PUBLIC SAFETY FACILITIES STUDY CARVER, MA

PROPOSED NEW CARVER POLICE HEADQUARTERS **EXISTING PLAN REVIEW**

June 16, 2009

C. <u>Site Plan Review Comments</u>

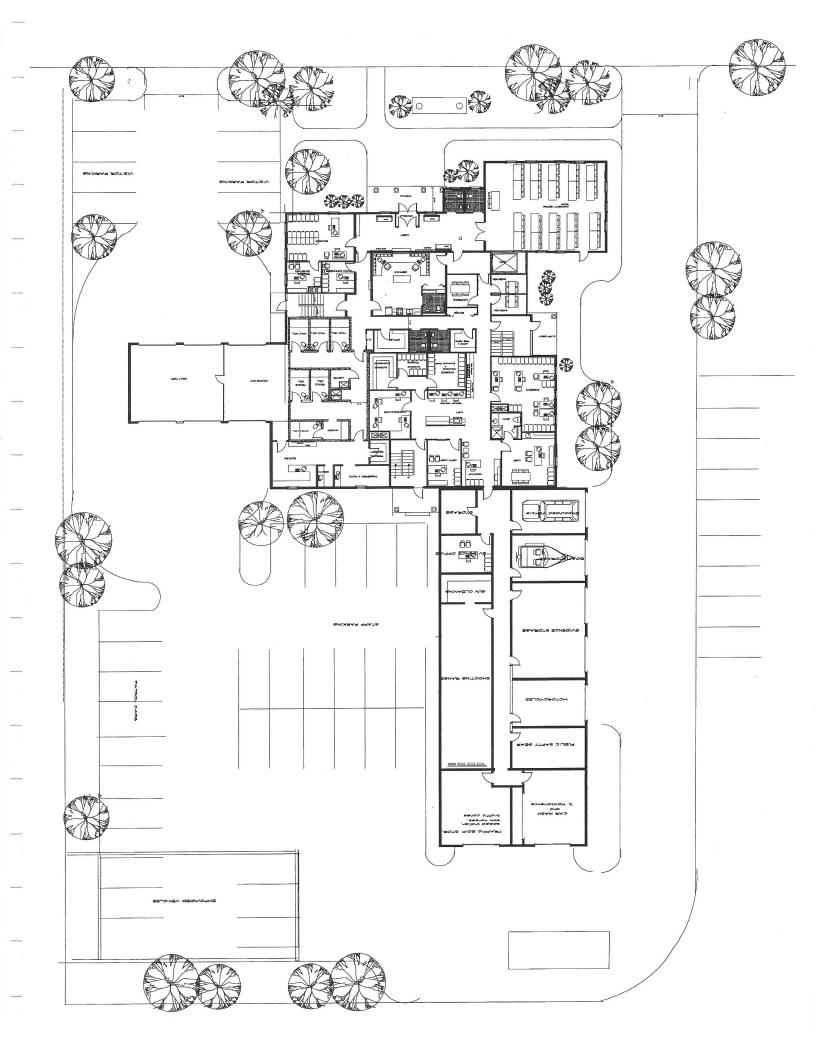
- 1. Visitors parking is split 4 spaces each side of Building requiring visitors to exit site onto Route 58 if visitors spaces filled, and re-enter opposite Visitor's parking area. Recommend one unified Visitors' parking area.
- 2. Staff entrance should be re-labeled to rear Building entrance nearest staff parking area.
- 3. Drive though Sally Bays are convenient for Officers but also require more site area for vehicular access, aprons and vehicle circulation. Based on existing limited site area and dimensions we recommend studying non-drive through Sallyport Bay option.

4. Impounded vehicle area (fenced) is in a visually exposed area with no space for landscape screening/barrier.

D. <u>Exterior Elevation Review Comments</u>

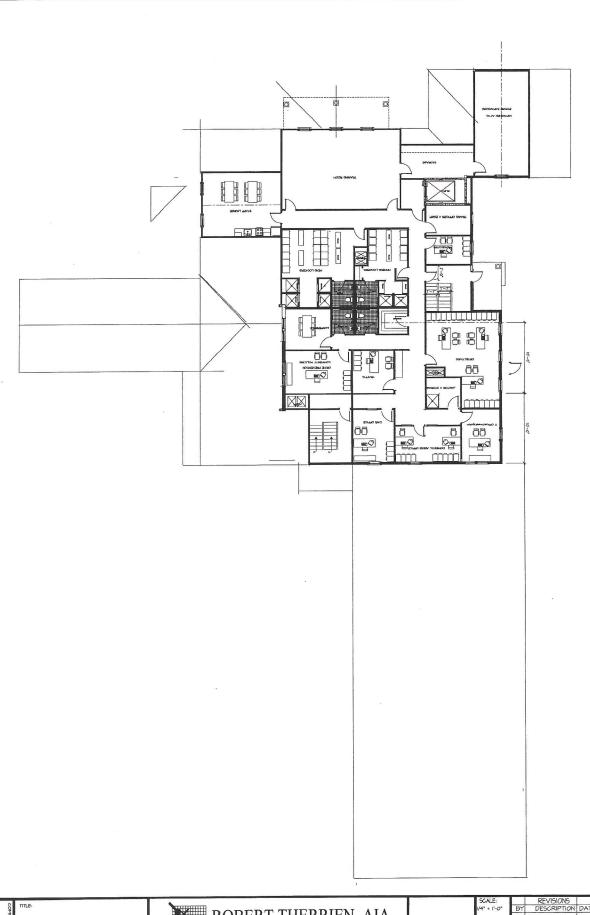
1. Narrow Sallyport wing would have low roof and ridge line and is not shown correctly on exterior elevations.
